Subject: MHI's Revised Response to US-APWR DCD RAI No. 769-5797 Revision 3 (SRP 15.0)

MHI's Revised Response to US-APWR DCD RAI No. 769-5797
Revision 3 (SRP 15.0)

US-APWR Design Certification

RAI NO.:	**NO. 769-5797 REVISION 3**
SRP SECTION:	**15 – INTRODUCTION – TRANSIENT AND ACCIDENT ANALYSES**
APPLICATION SECTION:	**15.0**
DATE OF RAI ISSUE:	**6/14/2011**

Figure 15-29.3 Core Heat Flux versus Time
Steam System Piping Failure (Case A)

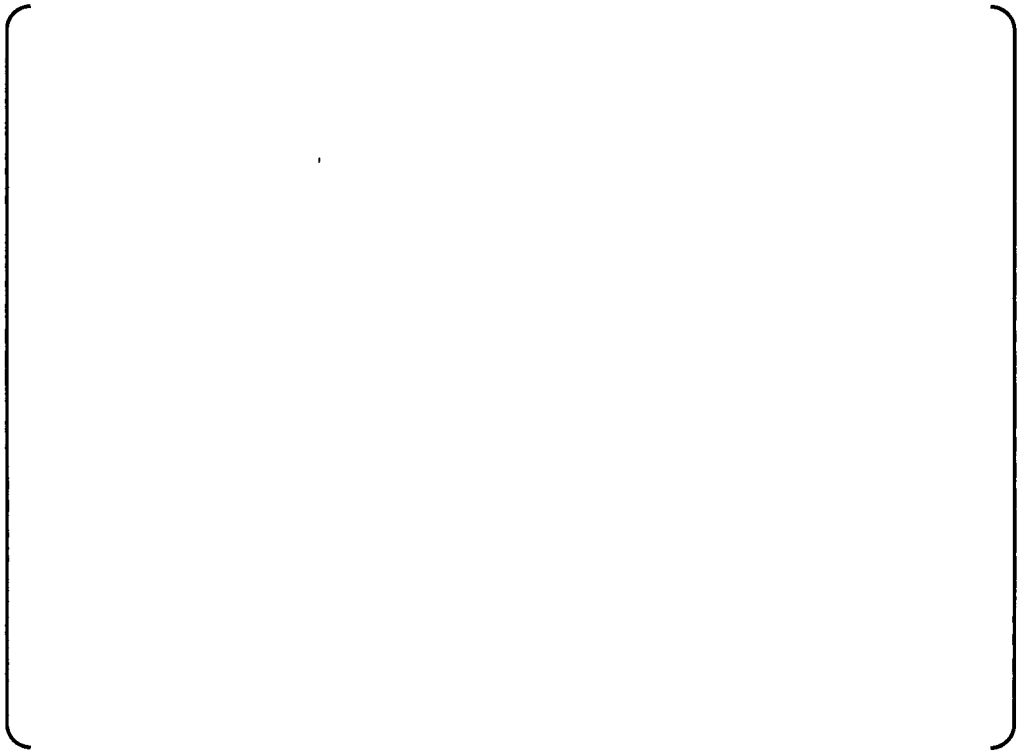
Per Table 15.0.0-10.1 (included in the response to RAI 15.0.0-10), the increase in heat removal transients analyzed in Sections 15.1.1 through 15.1.5 assume 10% of the steam generator tubes are plugged. This appears to be non-conservative because it reduces the heat transfer from the primary to secondary system, lessening the severity of these cool-down events. Please justify this assumption.

In order to determine the impact of the SG tube plugging used in the initial conditions for the events in DCD Section 15.1, MHI has performed a sensitivity study. The sensitivity study was performed for the steam line break in Section 15.1.5 since this is the limiting event in this group of events (increase in heat removal). The sensitivity analysis which assumes the 0% SG tube plugging was performed for steam line break Cases A (with offsite power), B (without offsite power), and C (at power). The results of the sensitivity study are shown in Figures 15-29.1 through 15-29.31. These results show that the impact of the SG tube plugging assumption is negligible and all applicable limits continue to be met. Therefore, MHI assumes the 10% SG tube plugging in the increase in heat removal transients (Section 15.1.1 through 15.1.5) as a consistent assumption with the rest of the DCD Chapter 15 transients.
